Santoft Groundwater Model and Rangitikei Groundwater Management Zone Allocation Limit Technical Review

Santoft Groundwater Model and Rangitikei Groundwater Management Zone Allocation Limit Technical Review

Dr Huma Saeed
Horizons Regional Council

Dr Hisham Zarour

Figure 4-22. Scatter plot of measured groundwater levels and the 2023 model-calculated groundwater levels at cell centres at the end of the stress periods in which the dates of measurement fall.

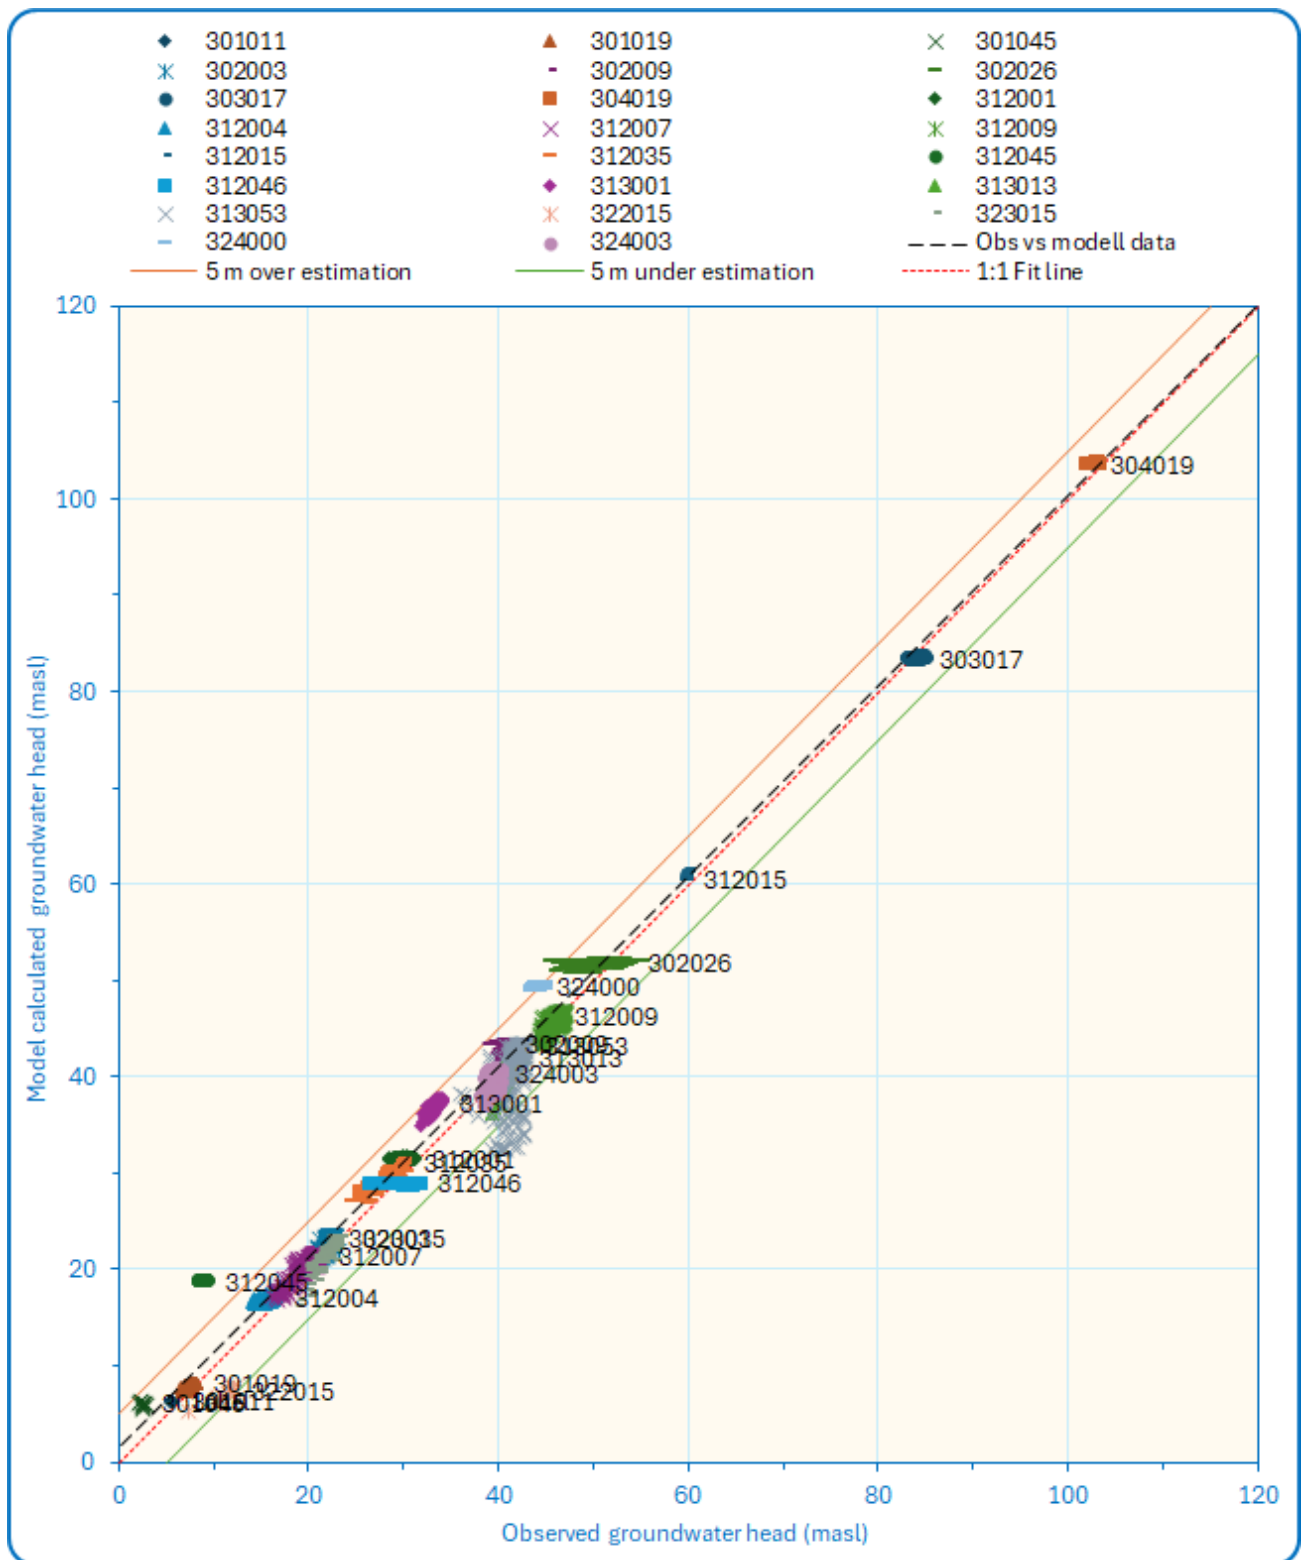
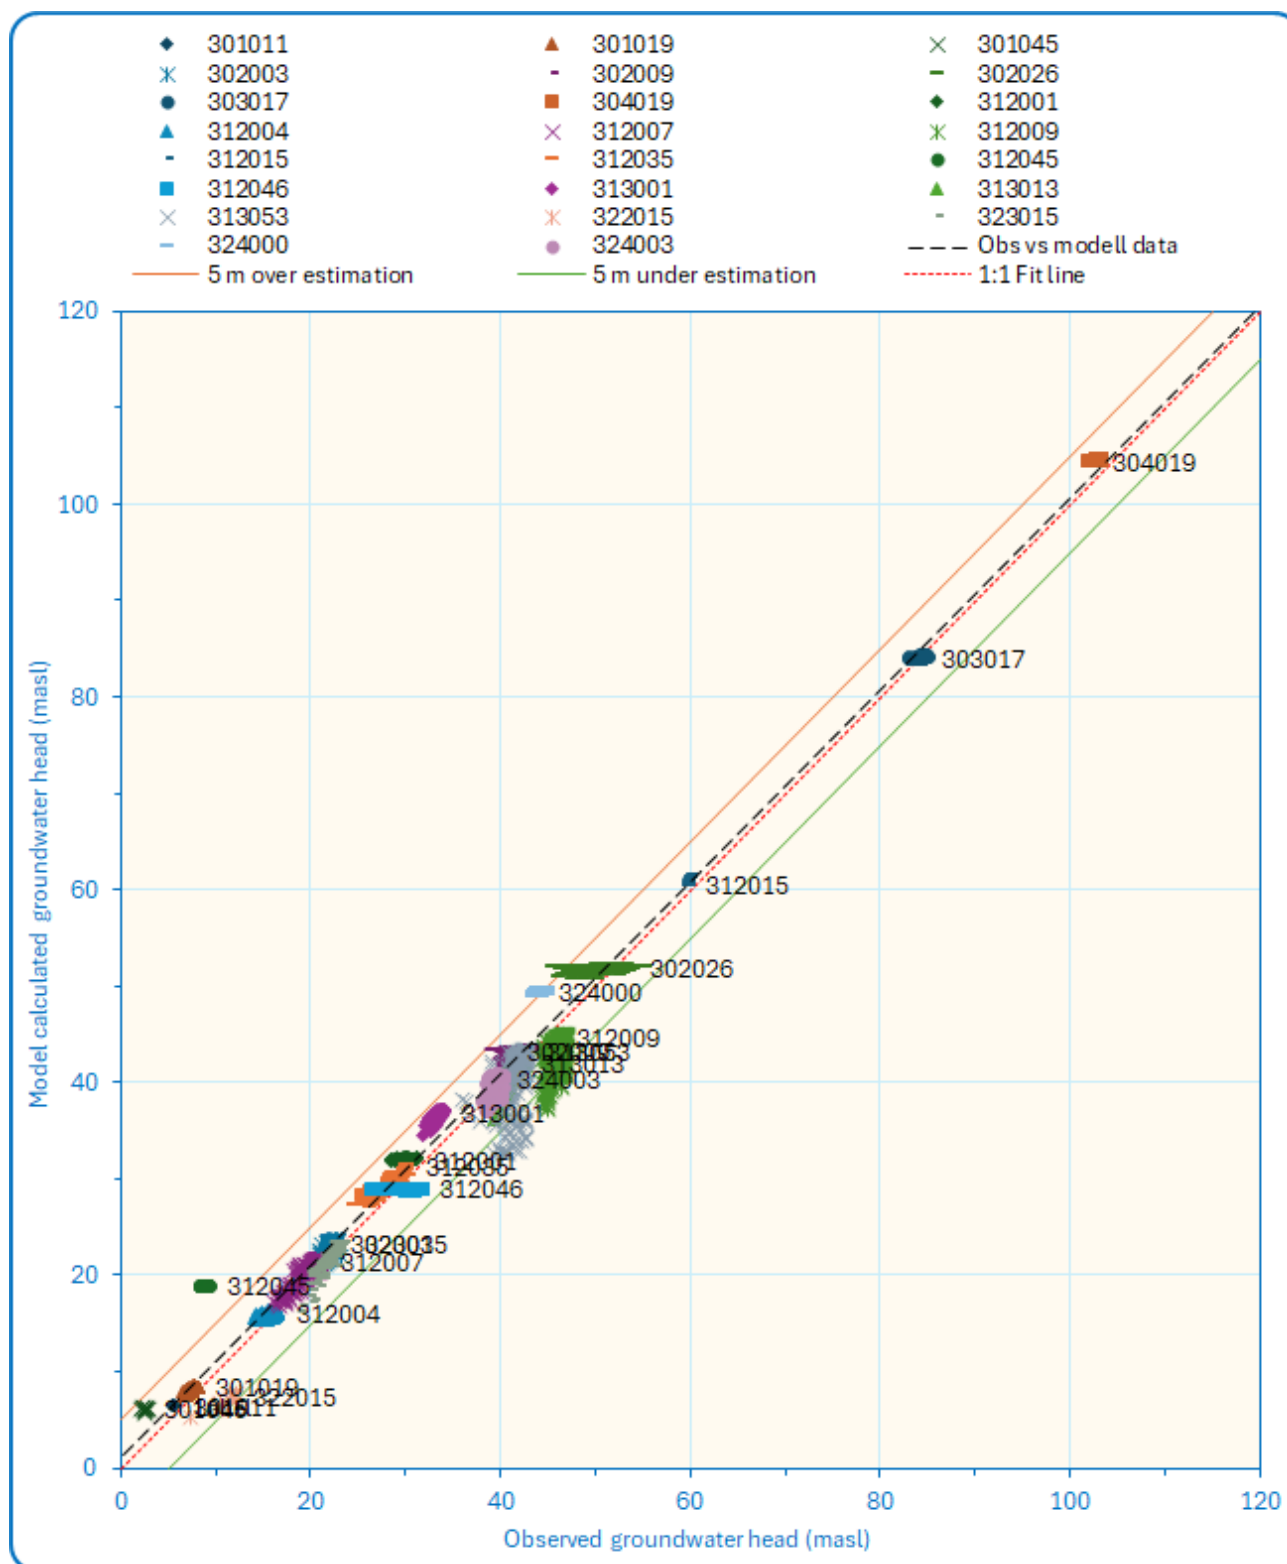
Similarly, it was noticed that in scatter plots the measured groundwater levels were compared to the model calculated groundwater levels at the centre of the cell and the end of the stress period within which the measurement date falls (Figure 4-22). This means that the time difference between the measured and model calculated groundwater levels can be up to 30 days. Therefore, the measured groundwater levels were plotted against model groundwater levels calculated at the bore site and the date of the measurement (Figure 4-23), which is the recommended approach. The difference between Figure 4-22 and Figure 4-23 cannot be seen easily, but it is clear in the data for Bore 313013 (Figure E-3). The scatter plot is broken into segments to enhance its scale in Appendix E.

Table 2 in PDP (2017) reports calibration statistics for the first model. The correlation coefficient (R^2) is 99.65%, which is very high, suggesting excellent model calibration (also see Figure 4-22 and Figure 4-23). Calibration metrics are not presented in PDP (2023). According to Barnett *et al.* (2012), the goodness of fit between model calculations and observations is often measured using a simple statistic, including:

Figure 4-27. Groundwater level contours for Layer 4 in October 2014 as presented in in Figure 19 in PDP (2017) compared to the same data extracted from the 2023 model files.

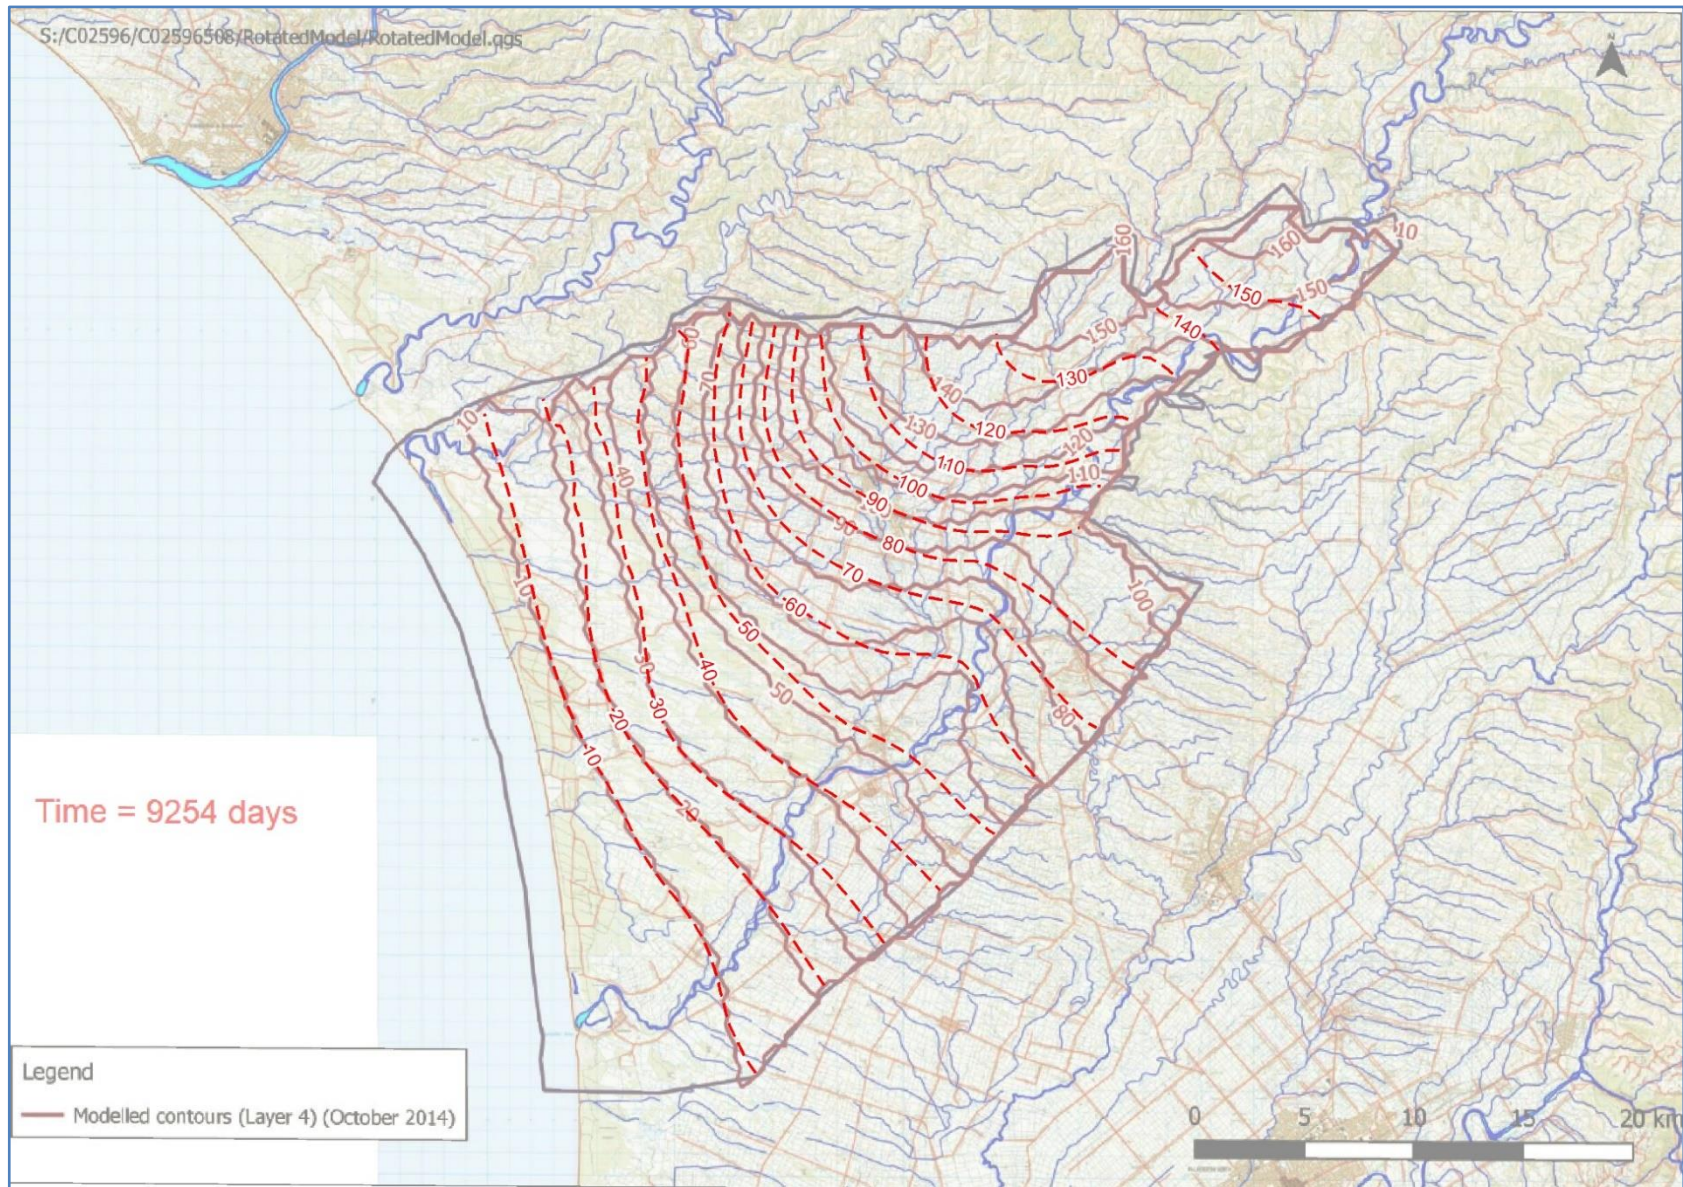
The resolution of the modelled groundwater levels map presented in Figure 19 in PDP (2017) is inadequate to show conditions near the coastline. Careful examination of the 2023 model files reveals that the model calculated head at the coastline is excessively exaggerated. Figure 4-28 presents the model-calculated groundwater head in Layer 1 around the coastline from the start to the end of the simulation period at eight-year intervals. The contour interval in the figure varies to clarify the situation. The head values are around 6 masl at the coastline, indicating a serious error in the implementation of the GHB boundary conditions at the western end of the model domain. This error is due to the offshore location selected for the western peripheral model boundary and the parameterisation of the GHB conditions designated there. These modelling errors introduce a high level of uncertainty in the model's historical simulations and future scenario predictions, necessitating correction in future model revisions. Note that PDP (2017) reports that GHB boundary conditions were set at the coast in Layers 1–3 but examination of the 2023 model files reveal that they are applied to Layers 1–6. Such reporting omission degrades confidence in the model even further.

Figure 4-29. Comparison between shallow groundwater level contour lines (black) presented in Figure 5 in PDP (2017) and groundwater level contour lines for Layer 1 in the 2023 model (purple). Both maps are for 1 October 2014 conditions.

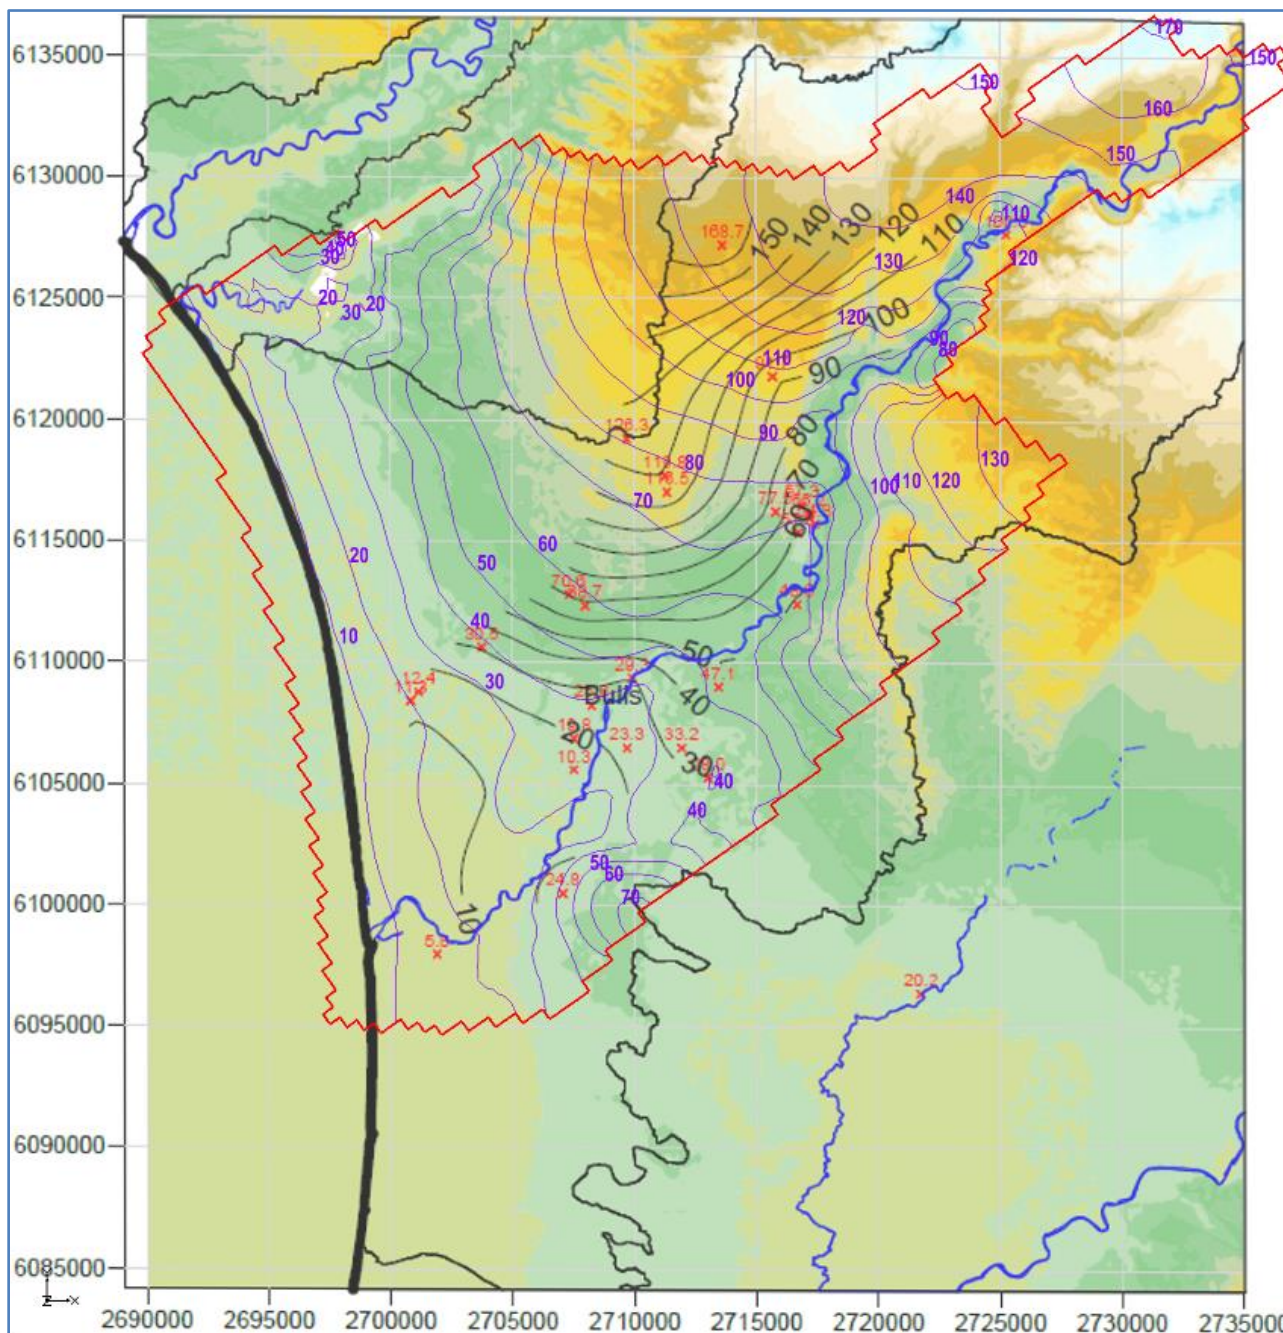
It is noticed that the shallow groundwater level contours in PDP (2017) differ from the groundwater level contours extracted from the 2023 model files in terms of values and the general flow pattern (Figure 4-29). This is an essential check of the model calibration that indicates that the model is not representative of real-life conditions.

Figure 4-32. Example on the change in water balance between the null and predictive scenarios (Figure 17 in PDP, 2023).

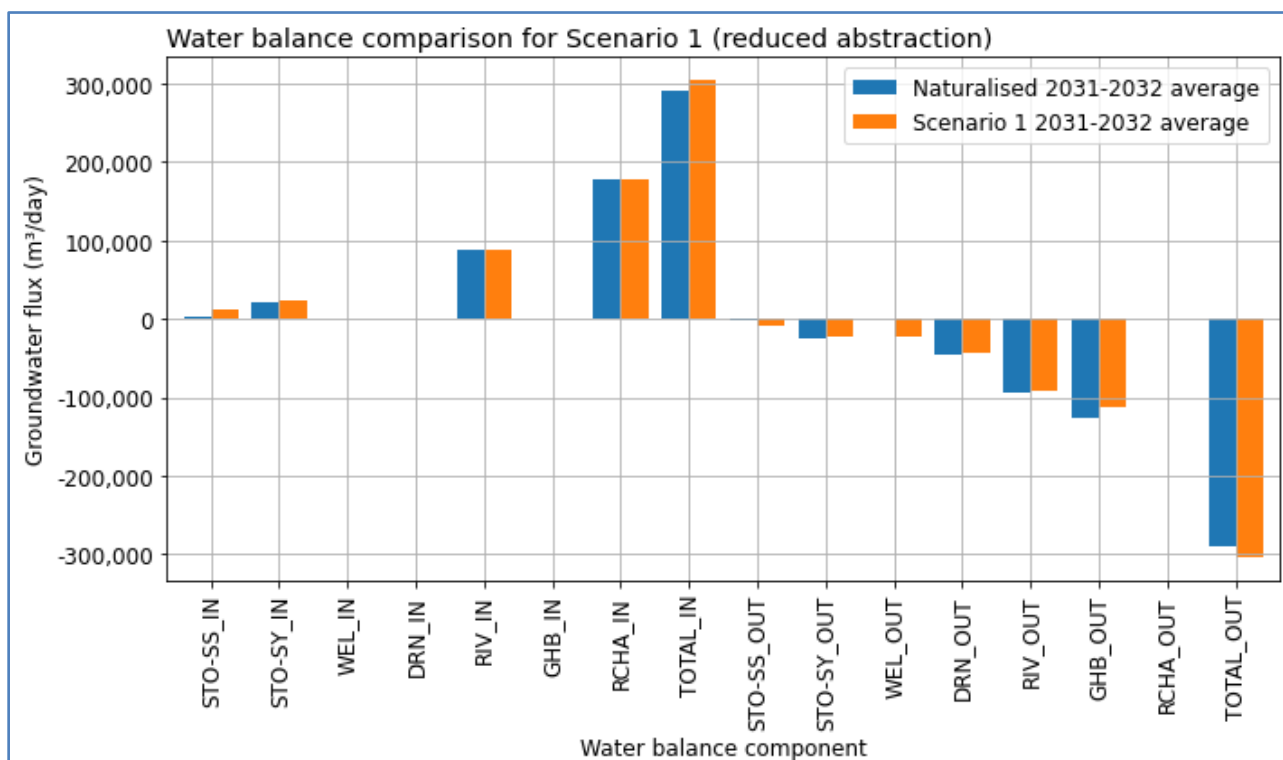
The water budgets presented in PDP (2023) for the calibrated model and predictive scenarios (e.g., Figure 4-32) show that the features represented as rivers and drains (DRN_OUT, RIV_OUT, RIV_IN) have a greater impact than groundwater abstraction (WEL_OUT), which is assumed to be a major stress on the groundwater system by the conceptual model. This indicates that future models should focus on improving the representation of these features.
